Subject ▶ Change on Housing set, Head (complete) and Spur gear 28

For Models ▶ 6702D,6703D,6702DW,(Cordless Angle Impact Driver)

Description ▶ Change of Housing set

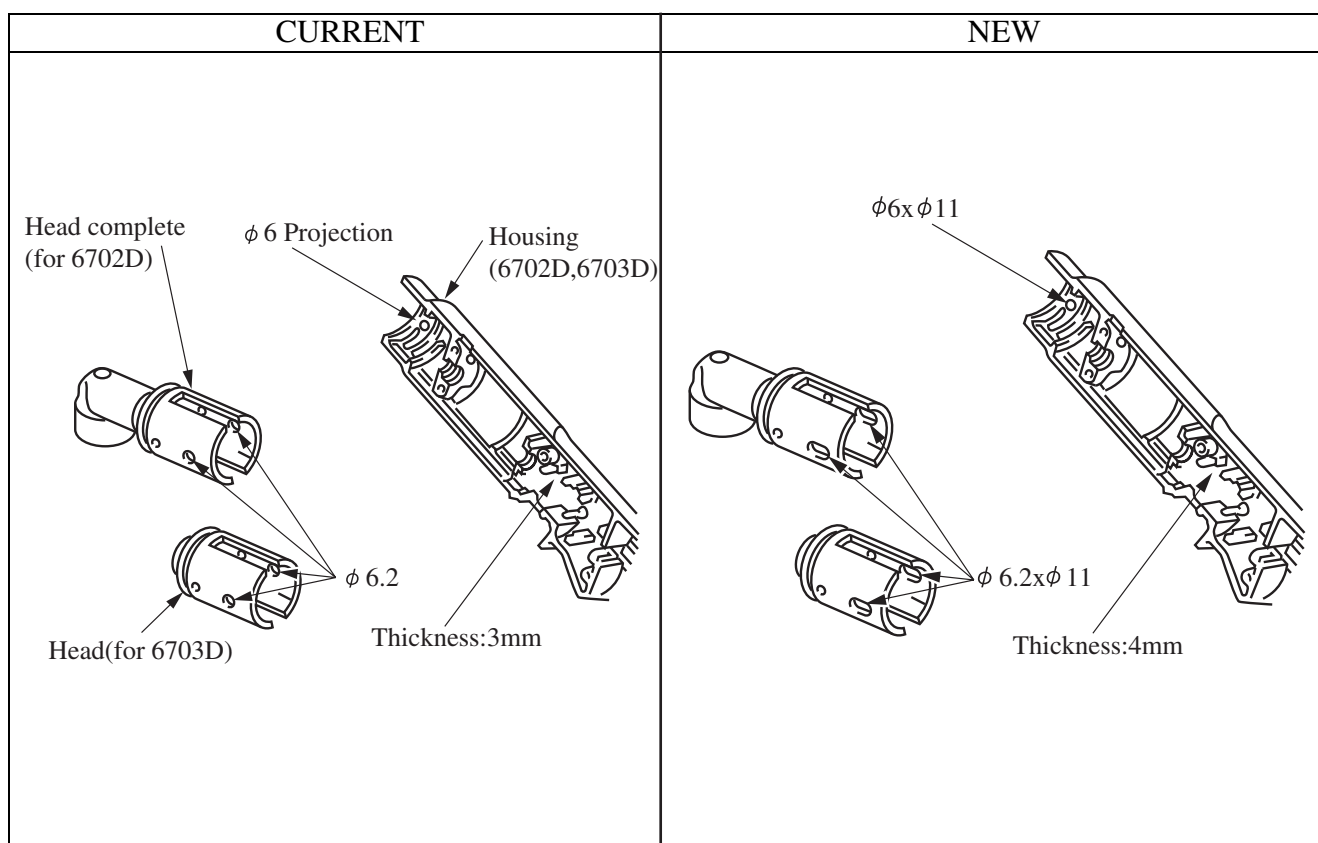
The shapes of projection for fixing position of Head (complete) have been changed from round to ovals; $\phi 6 \Rightarrow \phi 6 \times \phi 11$.

thickness of switchroom has been changed; $3\text{mm} \Rightarrow 4\text{mm}$

According to above change,the shapes of hole of Head (complete) for fixing postion have been changed from round to oval; $\phi 6.2 \Rightarrow \phi 6.2 \times \phi 11$.
